Haddam Neck Plant  
Millstone Nuclear Power Station, Unit Nos. 1 and 2  
Fire Protection

ATTACHMENT 1

FIRE PROTECTION

MILLSTONE NUCLEAR POWER STATION, UNIT NO. 2

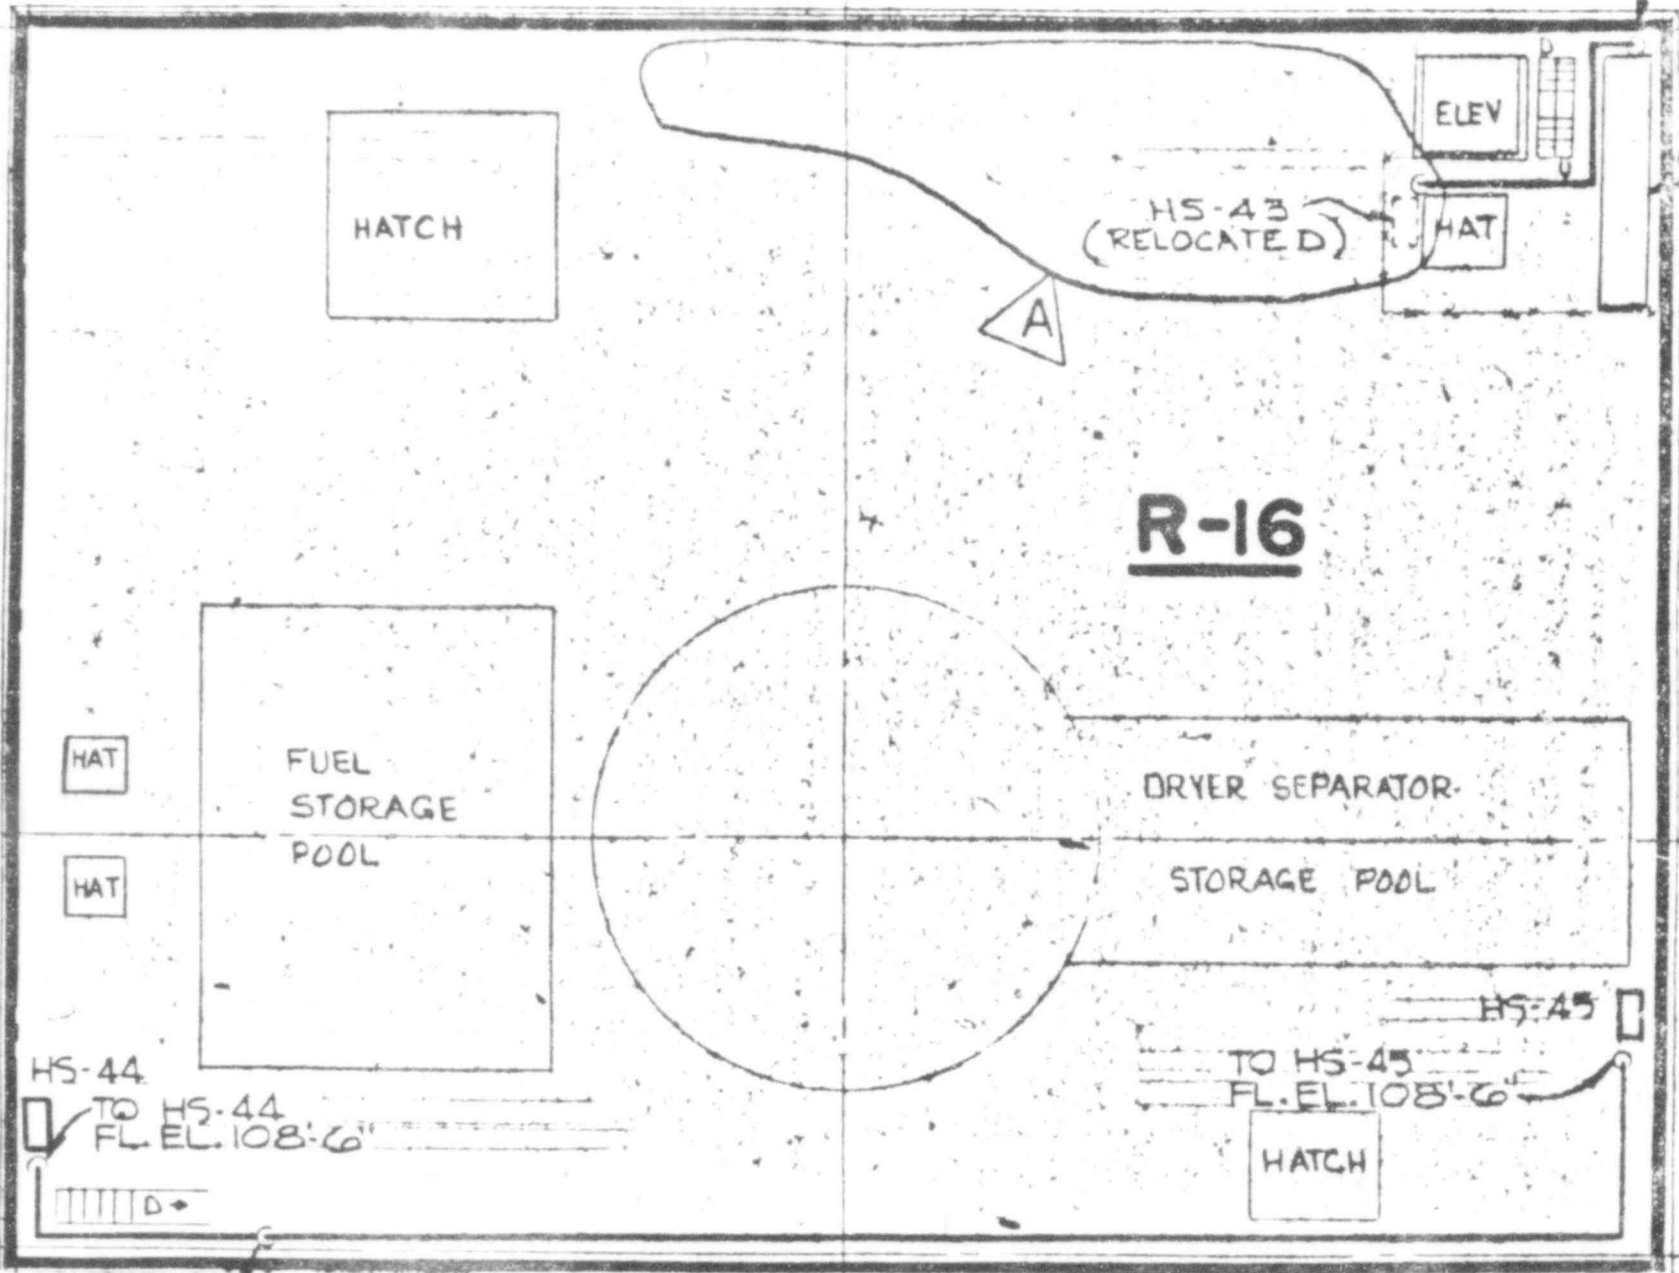
Hose stations will be verified to be capable of supplying a pressure of 65 psig at the nozzle under flowing conditions. Larger pipe sizes will be provided if required to provide a hose nozzle pressure to ensure adequate hose stream throw (4.3.1.d)(5.3).

The hose stations selected for this evaluation were H.S-44 and H.S-45 as shown on attached sketch. Please note that the location of the hose stations selected is the 108'6" level of the reactor building. The reason for this selection is that the 108' level represents the most severe conditions from a pressure consideration. Hose station #43 is also located at this level but was not pressure tested. This hose station is being relocated on the stairwell area for better coverage and, therefore, new pipe size and length will be provided to exceed the required pressure.

Static Pressure	Residual Pres. Gage at H.S.	Residual Pres. Gage at Nozzle	Pipe Length to Riser	No. of Fittings
H.S. #44	92 psig	78 psig	72 psig	32 ft.	7-90° elbows
H.S. #45	92 psig	70 psig	65 psig	132 ft.	7-90° elbows 1-45° elbow

Based on the actual test data documented above, Millstone Unit No. 1 concludes that their stand pipe hose station system complies with NRC's minimum requirements of 65 psig at hose station nozzle under flowing conditions.

NO	DATE	REVISIONS	BY	CHK	APP					
NORTHEAST UTILITIES SERVICE CO.										
FOR MILLSTONE UNIT 2										
TITLE REACTOR COOLANT PUMPS OIL COLLECTION SYSTEM										
NO	DATE	TITLE	BY	CHK	APP					
						SK. REF. 531

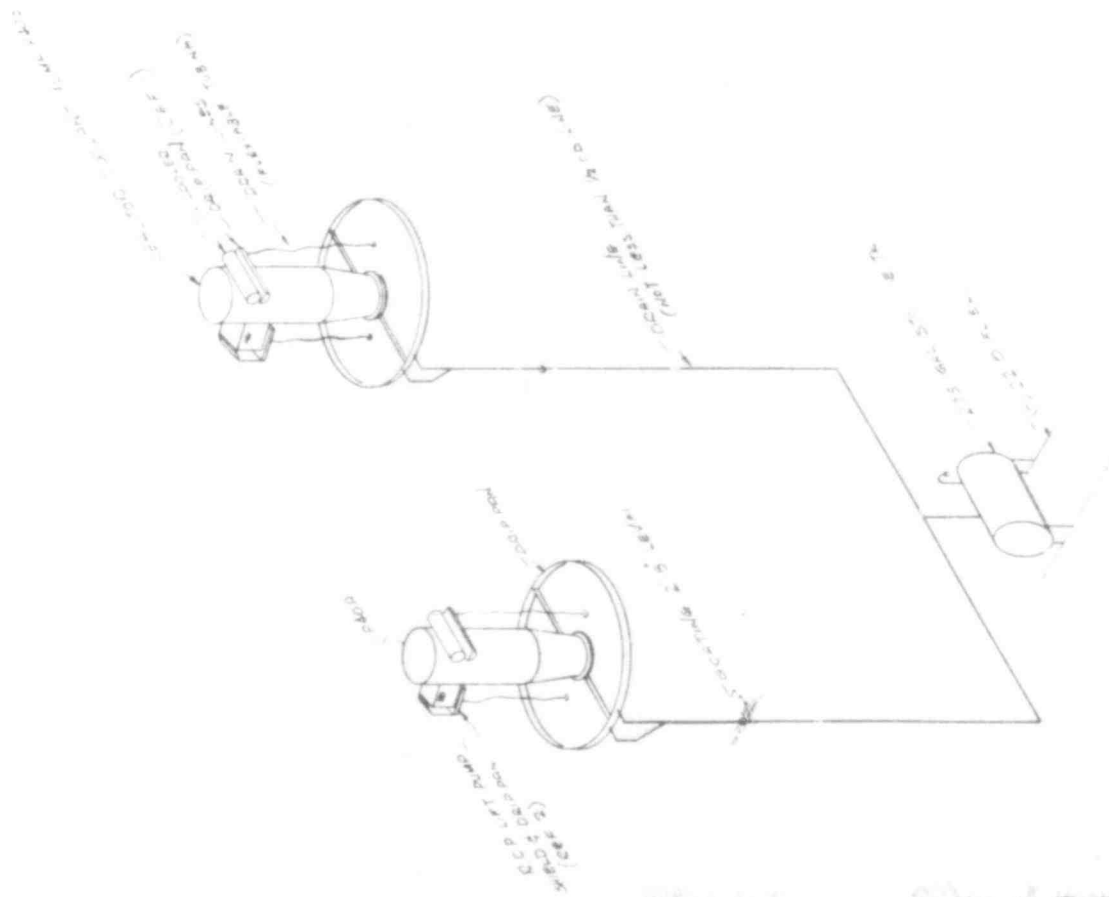
The licensee is evaluating a method of oil collection or routing to prevent the spread of oil or the use of alternative types of lubricants to reduce the fire hazards associated with the reactor coolant pump lube oil systems (5.10).

The type of oil collection and/or rerouting of RCP lube oil will consist of a main drip pan arrangement with a supplemental lift pump/oil cooler drip pan. The primary purpose of the drip pan system is to collect oil from all exterior leakage points (i.e., mechanical connections) around the RCP and route it to an acceptable tank storage area which will be located at the base of the RCP supports.

- (1) A drip pan with a 3" lip (minimum) will be installed around the base of the RCP motor top hat area. The drip pan will extend radially to the exterior location of potential leakage points such as the upper oil cooler lower reservoir oil level transmitter, and the high pressure lube oil system.
- (2) A deflection box/shield will be installed around the high pressure lube oil system to direct high pressure leakage to the drip pan.
- (3) Two one-half inch holes will be provided at either the bottom of the lip or in the base plate at the lowest elevation of the drip pan. One-half inch tubing will be run from the drain holes to the storage tank.
- (4) The one-half inch drain lines to the tank storage area will be tested after field installation to ensure that they are not clogged with debris.

An isometric sketch (SK-REB-531) is provided which illustrates the conceptual design for the system. This drawing is preliminary and final design will be established at time of installation. Installation is scheduled for the 1980 refueling outage.
